## ATTACHMENT 5: COMMENTS AND RESPONSES

# SALMON CREEK INTERCHANGE PROJECT

SUBJECT: SR5- SR 205 Salmon Creek Interchange Project  
Comments Environmental Assessment

Property #1: Identified by the Clark County Department of Assessment and GIS by Serial Number 185672-000. See Attachment #1.

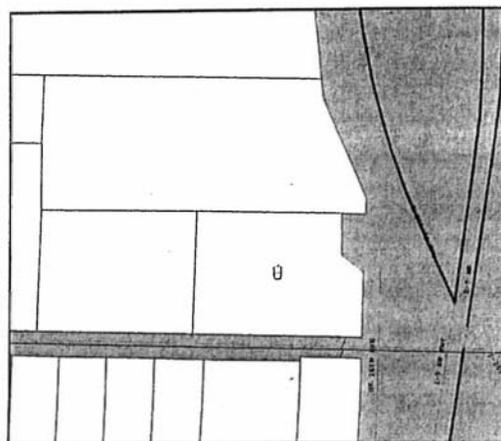
Property #1 is partially developed with Mountain View Veterinary Hospital which was established in 1981. This development is located on the North portion of the property leaving the South portion of the property open for future development. The property is currently accessed by NE 16<sup>th</sup> Ave. The South property line is surveyed such that the Easterly 147.32 feet extends to the center line of NE 139<sup>th</sup> St. while the Westerly 266.73 feet dedicates a 30 foot easement to the 60 foot width of 139<sup>th</sup> St. (See Attachment #4 as Survey of these properties). Currently there is improved access from NE 16<sup>th</sup> Ave into the Southeast corner of this property. With the proposed prohibited access, this access would be eliminated as would the additional access that is available on NE 139<sup>th</sup> St. We request that if the access to NE. 139<sup>th</sup> St. is prohibited, then the current improved access from NE 16<sup>th</sup> Ave. in the Southeast portion of this property be fully replaced as to

provide adequate access per county code to the undeveloped Southern portion of this property.

The project does not propose to remove access to the property in question (identified as Serial Number 185672-000 and described as #19 SEC 23 T3N R1EWM 2.95 A in the title report references in the comment issued by First American Title dated October 17, 2006). Access may need to be relocated so that it is not in conflict with the NE 139th Street alignment.

Property #2: Identified by the Clark County Department of Assessment and GIS by Serial Number 185796-000. See Attachment #2.

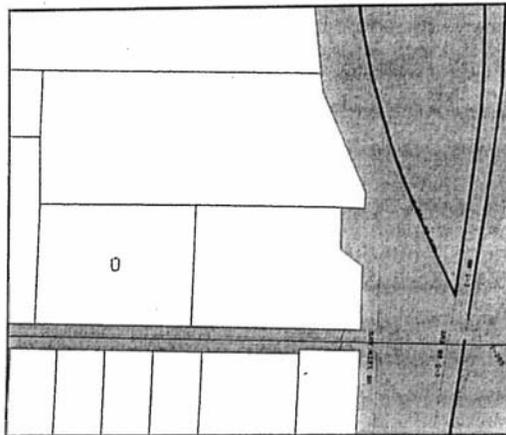
Property #2 currently has access to a deeded county easement known as NE 139<sup>th</sup> St. with recorded width of 60 feet. This proposal would eliminate all access to this property essentially making it landlocked with no ingress or egress, rendering it impossible for any development in its current land use designated as ML. We have previously requested that access privileges be given to this property.

*“This type of access will not be granted. However, Federal and State laws require just compensation for purchase of property or property rights. If less than an entire parcel is acquired, just compensation also includes losses in value or damages, if any, to the remaining property. This issue will be addressed by the appraiser during the appraisal process.”*
